STATE OF HAWAII
DEPARTMENT OF TRANSPORTATION
HIGHWAYS DIVISION

INTERSTATE ROUTE H-1
Kunia Interchange Improvements
F. A. I. Project No. 1M-HI-1(219)

SHEET No. L43 OF 52 SHEETS

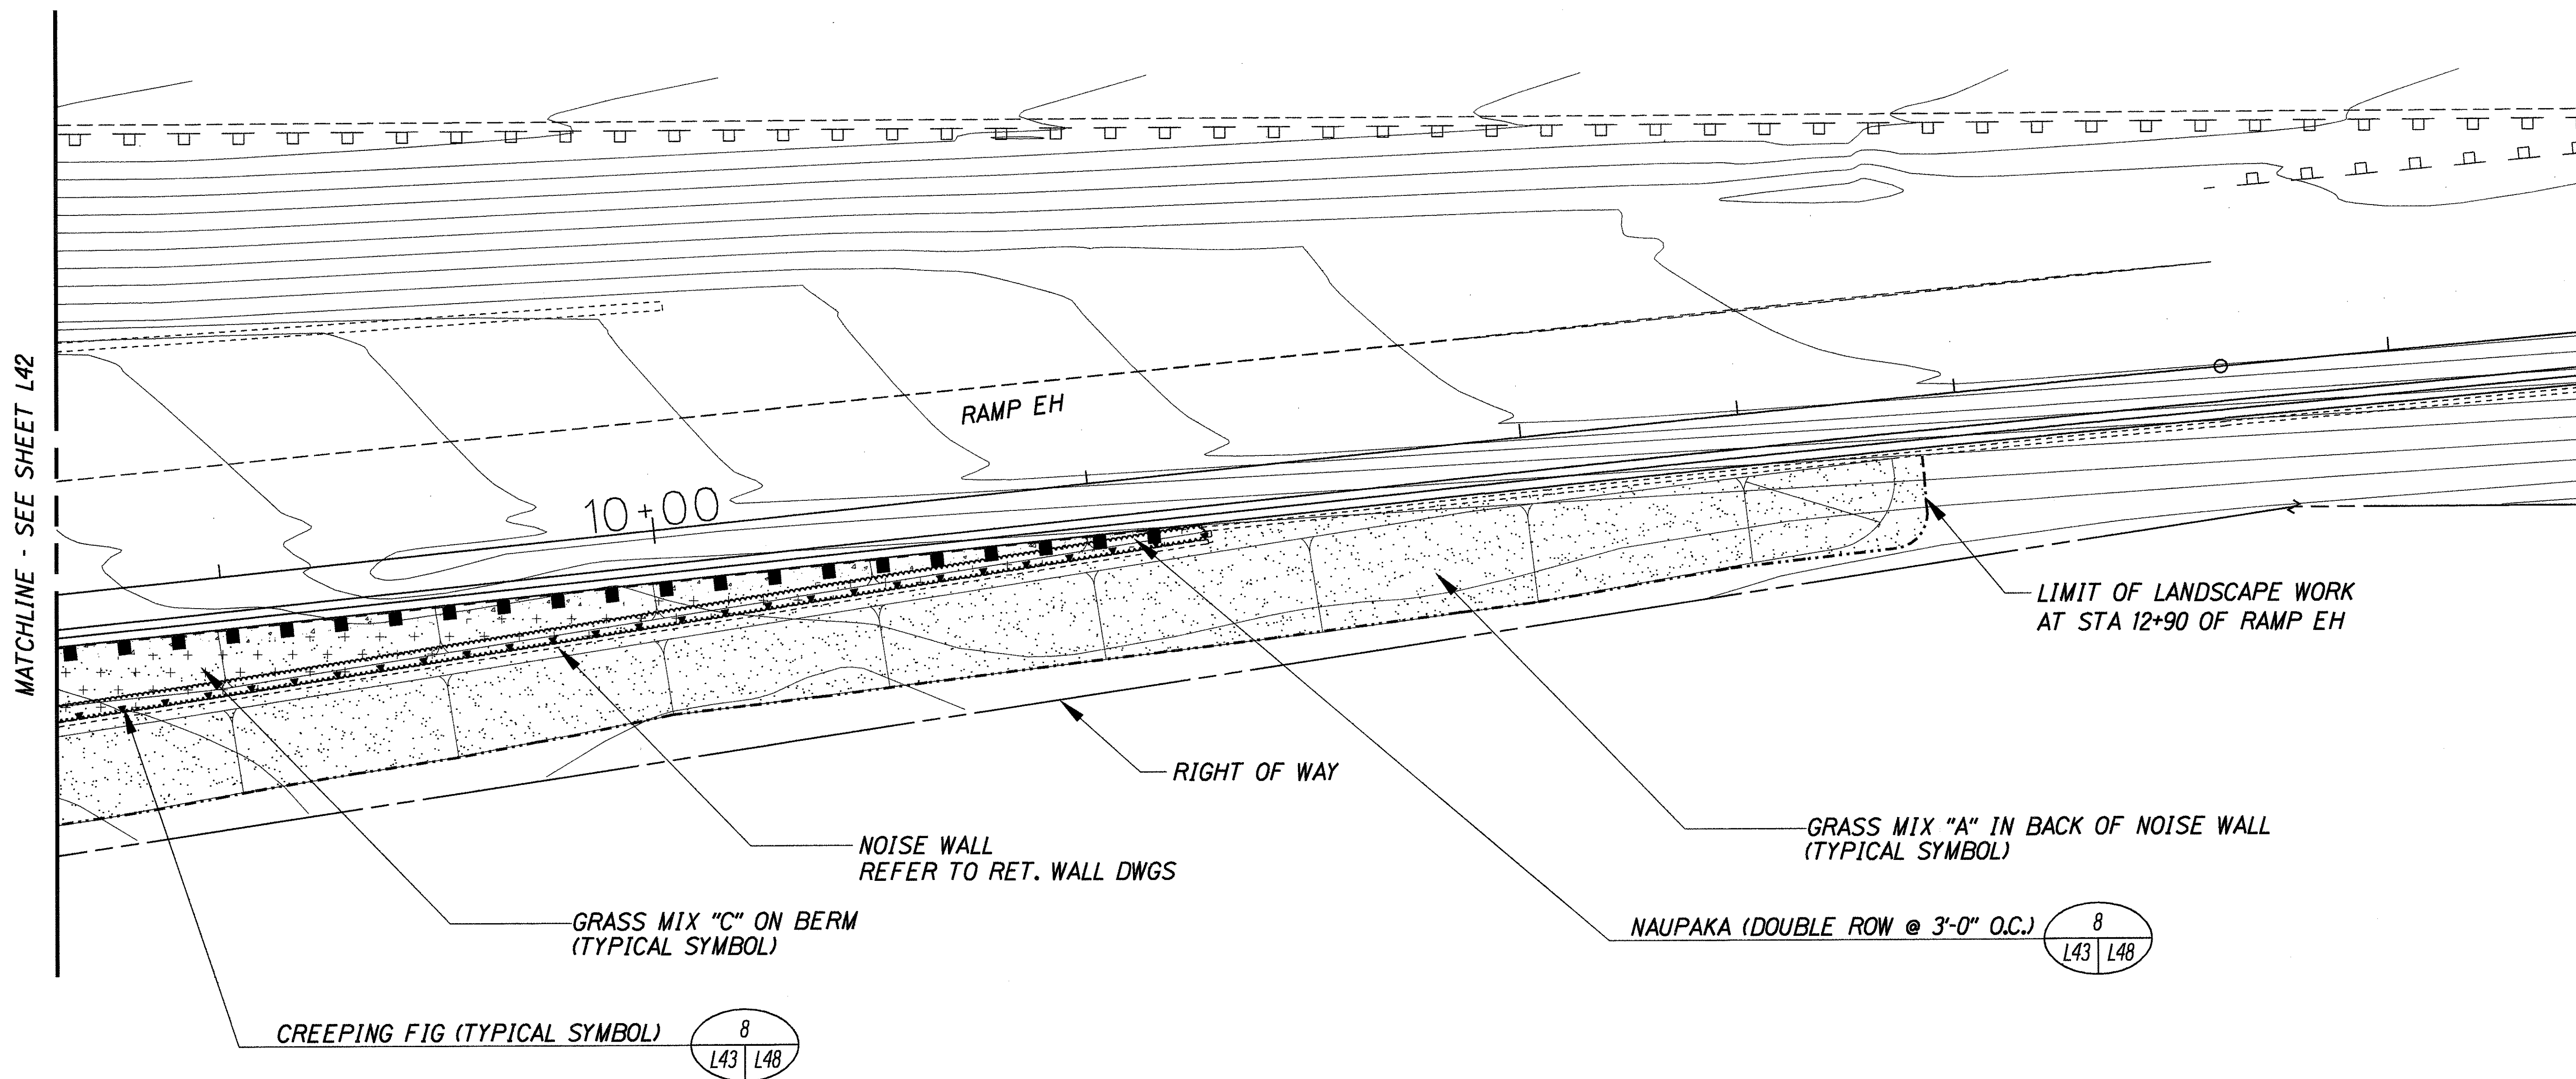
8/17/98	Revised Sheet to Add Naupaka and Creeping Fig in Front of Noise Wall Along Ramp EH.
DATE	REVISION

INTERSTATE ROUTE H-1
Kunia Interchange Improvements
F. A. I. Project No. 1M-HI-K(219)
Scale: 1"=20' Date: Oct., 1997
SHEET No. L44 OF 52 SHEETS

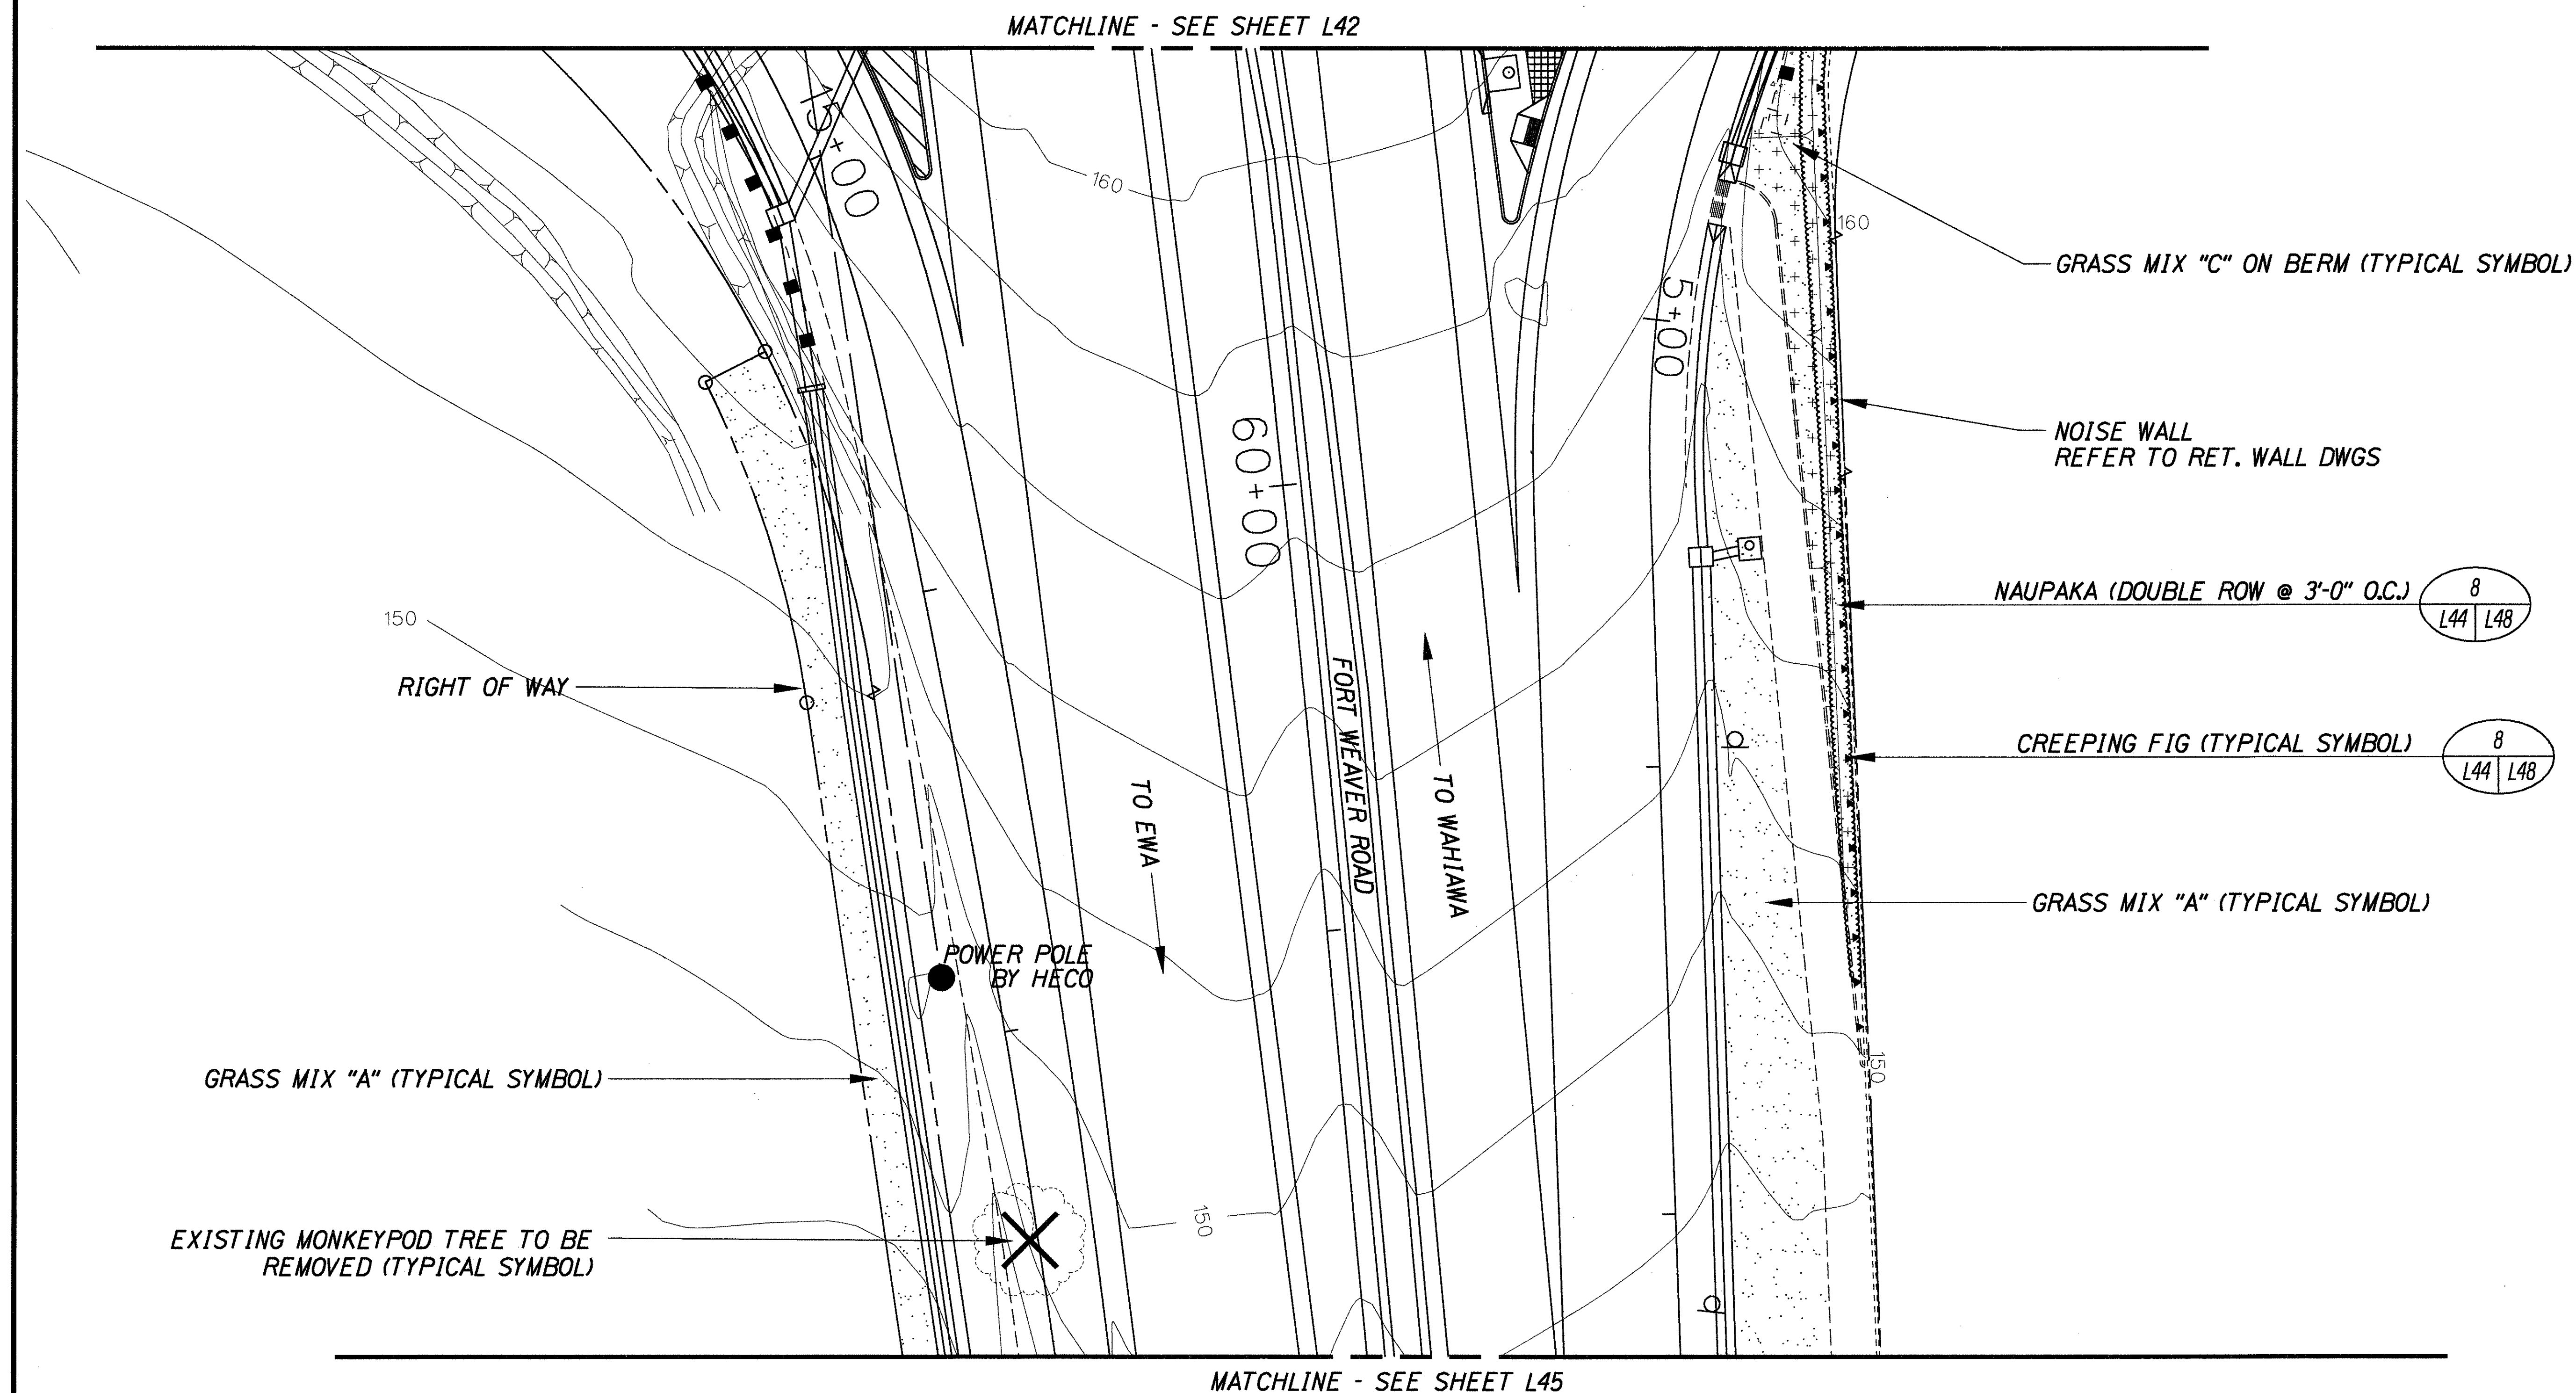
8/17/98	Revised Sheet to Add Naupaka and Creeping Fig in Front of Noise Wall Along Ramp EH.
DATE	REVISION
